Cost Risk Assessment and Value Engineering Workshop Report TH 101 Floodplain Bridge SP 1009-24

November 5-9, 2012

**Minnesota Department of Transportation
Office of Project Management and Technical Support
395 John Ireland Blvd. MS 696
St. Paul, MN 55155**

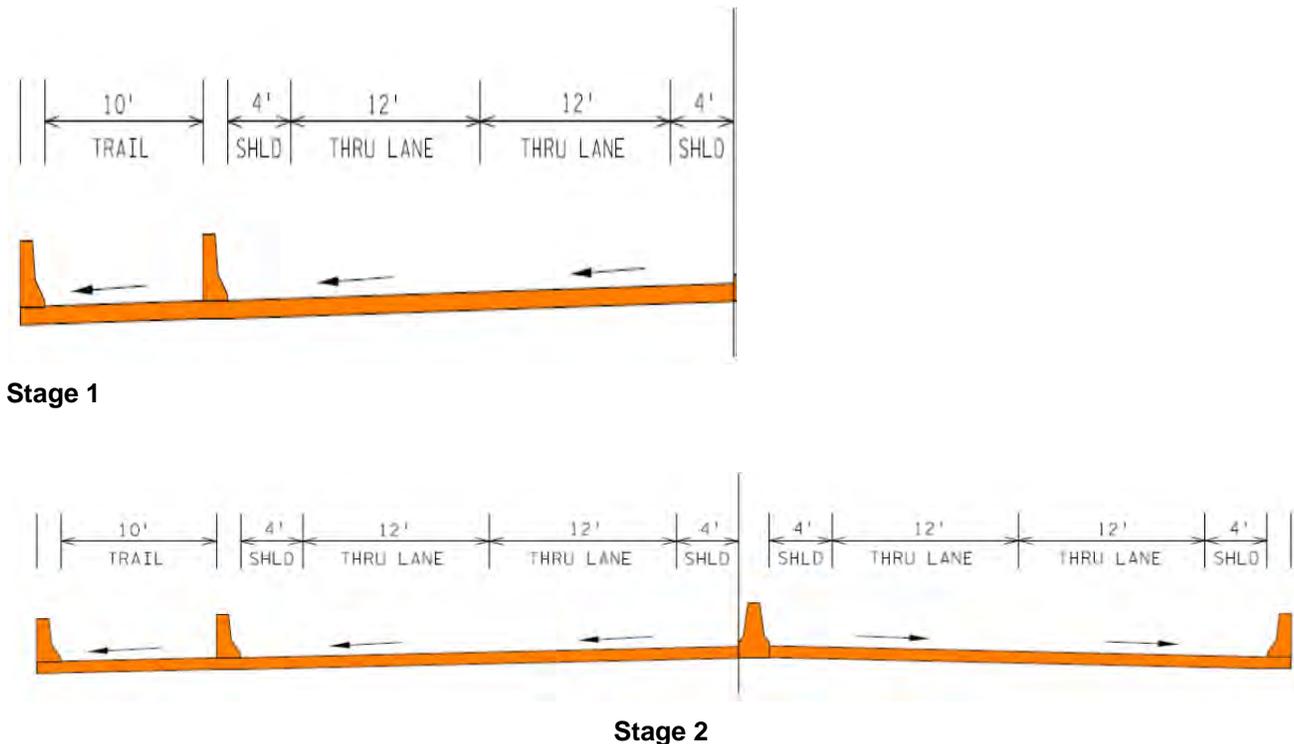
Building this project in 2 stages facilitates maintaining traffic during the total construction period with limited nighttime and weekend closures for work operations such as girder erection or material delivery (piling).

The west portion of the structure and approach embankments could be completed while traffic remains on the existing roadway. This will require adding temporary barrier to separate the traffic from the work zone. Travel lanes will be reduced to 11' lanes and 4' shoulders and will require an approximate 6' temporary shoulder widening on the east side of the existing roadway.

During stage 1 the west leg of the existing wye connection will be closed and a temporary signalized intersection will be added to handle traffic at TH-101 and CSAH-61, slightly east of the designed intersection.

10' trail bridge section

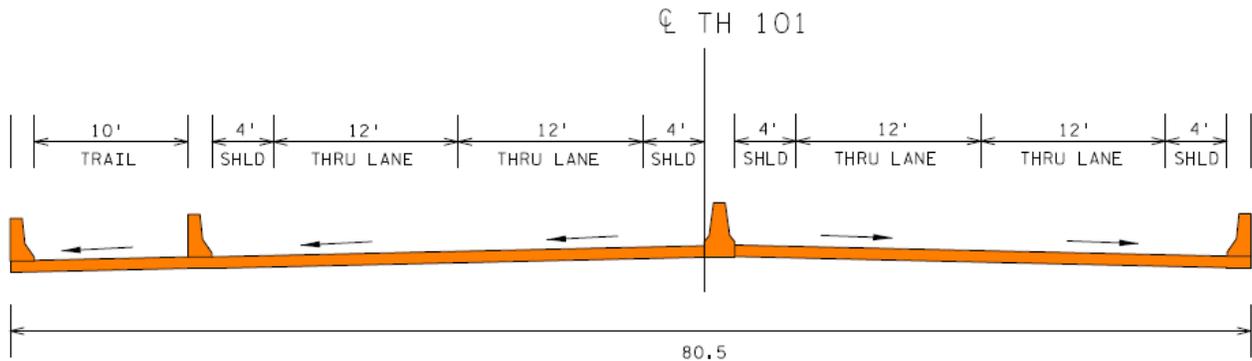
- ◆ Reduce Cost
- ◆ Meets desirable width for bike facilities per LRFD manual, and acceptable width per Bike Facility Design Manual
- ◆ Still allows access for snow removal and inspection equipment on the trail (10' minimum)
- ◆ May need a variance for SA Rule 8820.9995. The minimum bike path width required is 8', with an extra 2' shy to barriers. Per the rule, wherever practicable, carry the trail width plus shy across the bridge, or 12'.

Revised Bridge Section

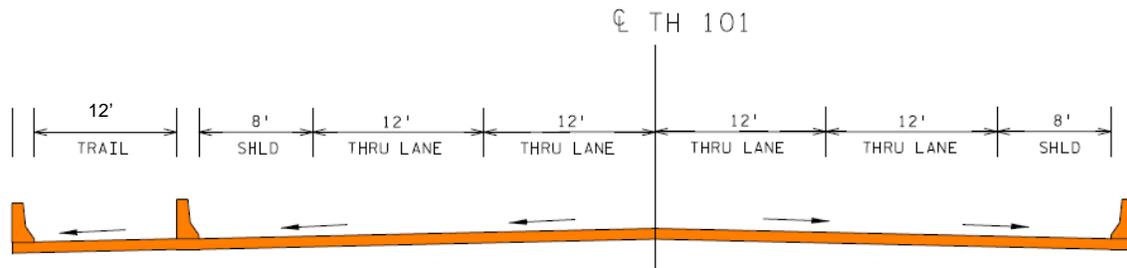
Revise the typical section to maximize the outside shoulder for drainage, snow storage, inspection, and emergency pull-off. This can be accomplished by removing the inside shoulders and increasing the outside shoulders to 8-ft which matches the rural section with 8-ft shoulders off the bridge, increased shoulder x-slope to 2.5%.

With an 8-ft outside shoulder and no median barrier (double yellow line) along with break shoulder cross slope to 2.5% on bridge deck to aid in drainage. A centerline structural rumble stripe would be added.

- ◆ Reduce Cost
- ◆ No defined standard for median barrier requirement on rural 4-lane undivided roadways (either bridge, state aid, or MnDOT Roadway Design Manual Section 4-5.0)
- ◆ Existing Minnesota River Bridge (No. 70002) to the south does not have a median barrier
- ◆ Allows for snow storage in the shoulder, although shoulder width would likely not be available if used for snow storage
- ◆ In conjunction with an increase in the cross slope on the shoulder to 2.5%, eliminate deck drains and meet spread criteria (base design assumed either a design exception for spread, or over 50 deck drains on the bridge).
- ◆ Add rumble stripes to assist in the prevention of cross overs
- ◆ Similar typical (no median barrier) to many high speed rural undivided roadways in the state and nation.
- ◆ May need to add a buffer (1') for the centerline rumble stripe.

Construct One-Way Wye

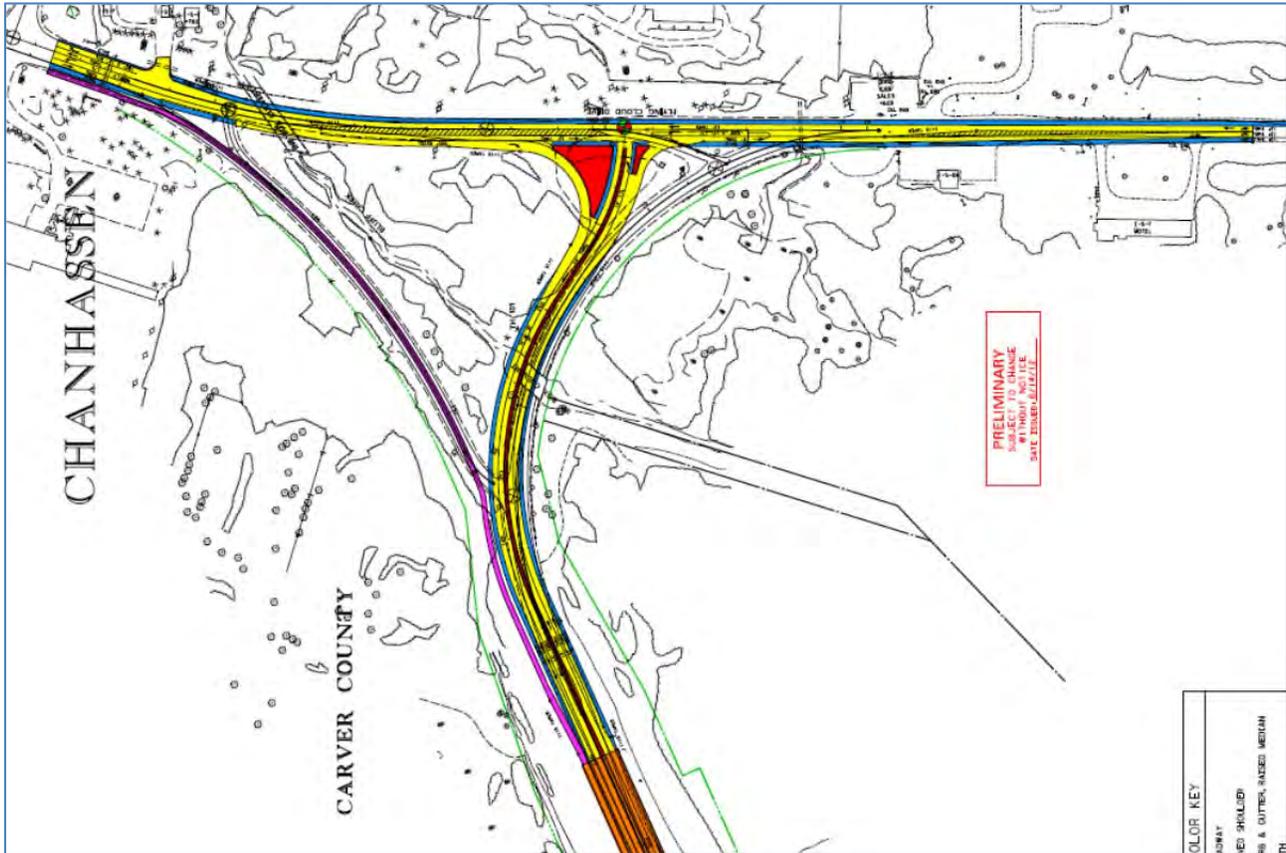
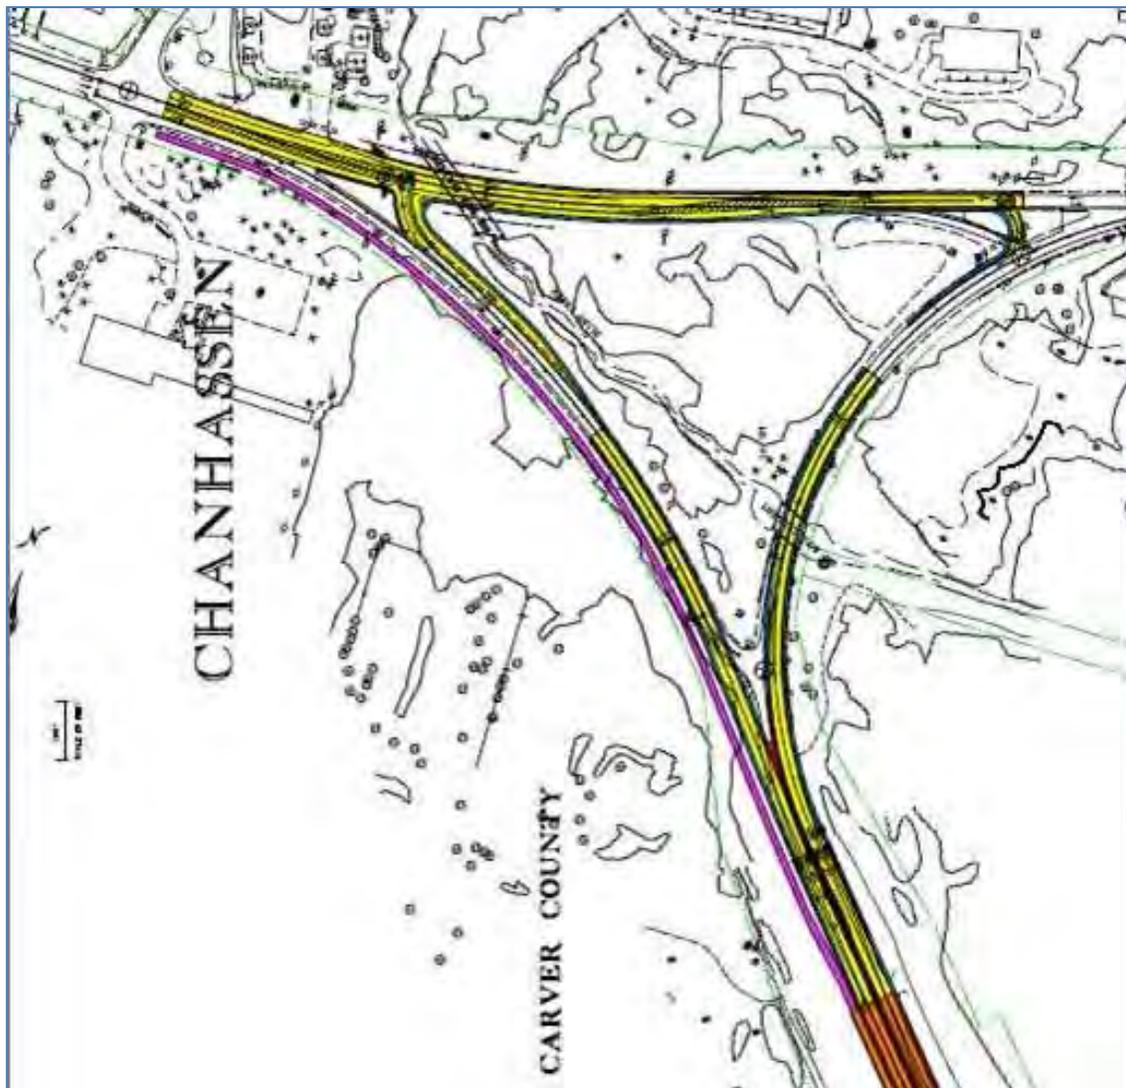
The baseline design constructs a simple T intersection along the east leg of the existing wye. This design does minimal work to CSAH 61 and is intended to give a 10 year design life.

The proposed trail is routed along the existing west leg of the wye.

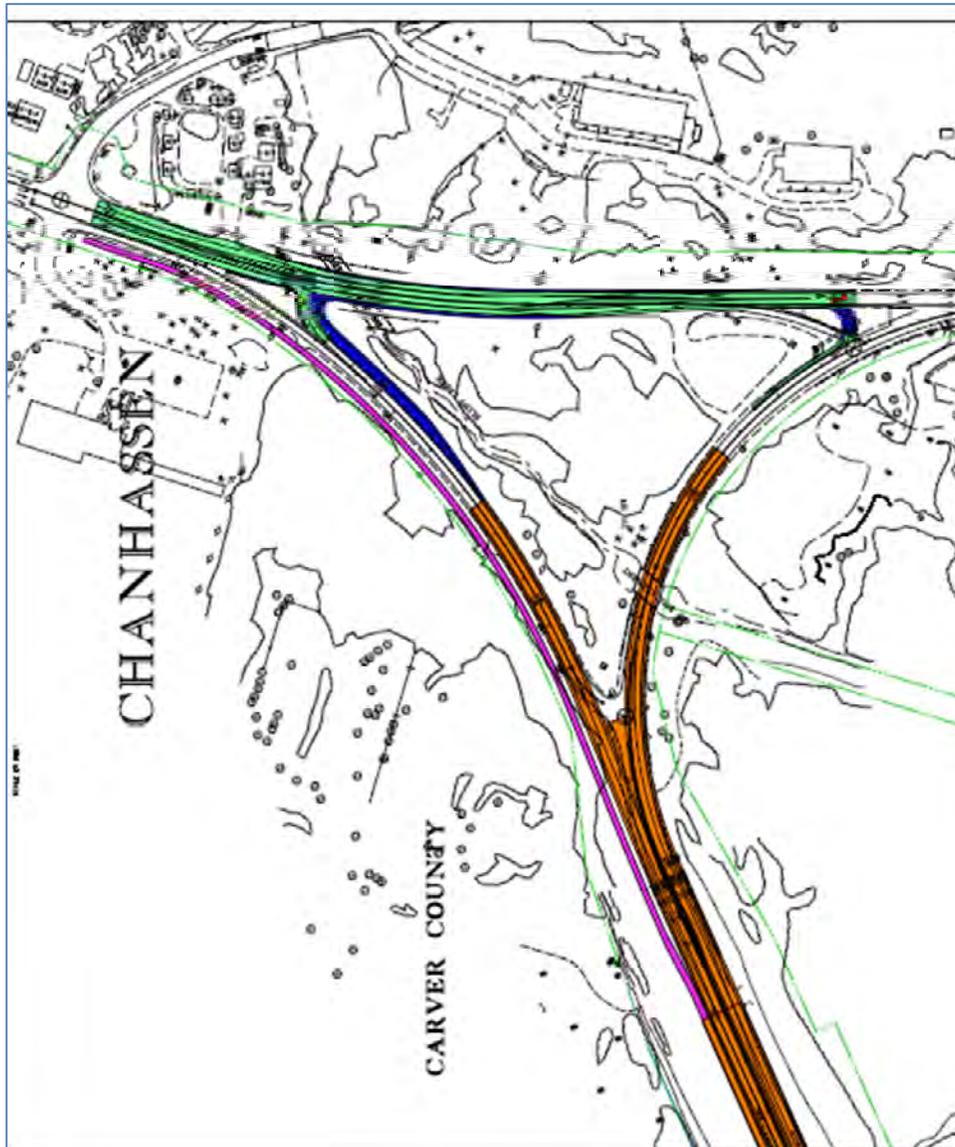
Extending the bridge, and eliminating the pile supported embankment, will save money because the estimate for the square foot cost of bridge (\$80/SF) on this project is less than the square foot cost for pile supported embankment (\$100/SF) although the costs for the Y section of this bridge will be increased.

This option also reduces the risk of weather delay since driving pile is less dependent on dry conditions than soil grading and compaction. The bridge option will also restore more of the flood plain and have less of an impact on Bluff Creek which will have a positive environmental affect.

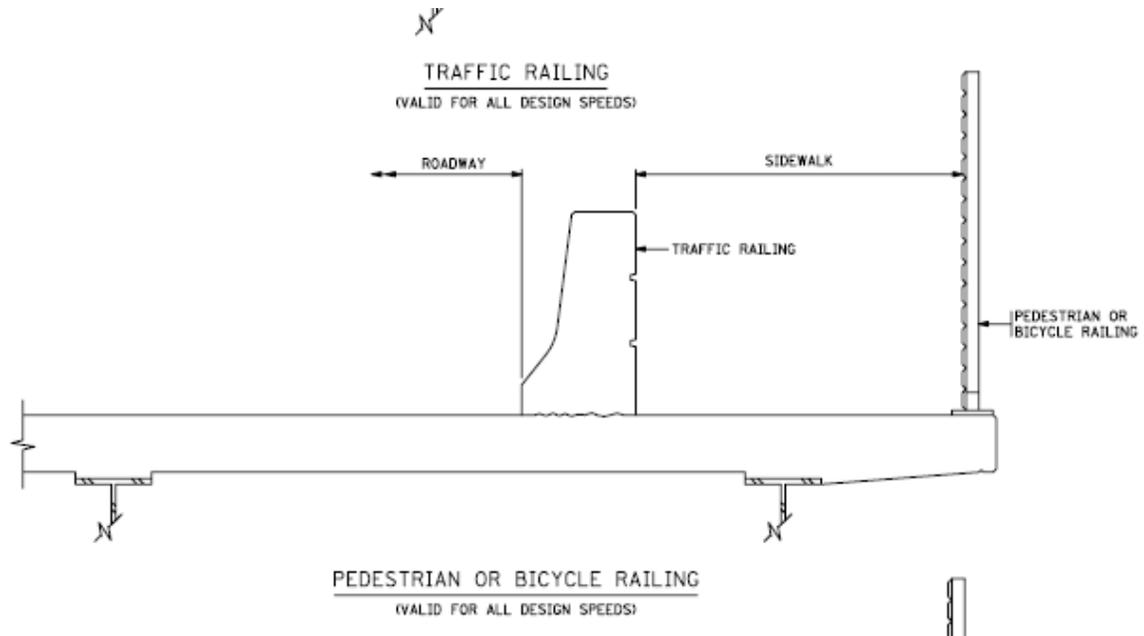
- ◆ Reduce Cost
- ◆ Aesthetics are less of a concern on this bridge because you don't have cross streets and paths that look at the bridge.
- ◆ Existing trail rail (BR 10007) is standard chain link fence
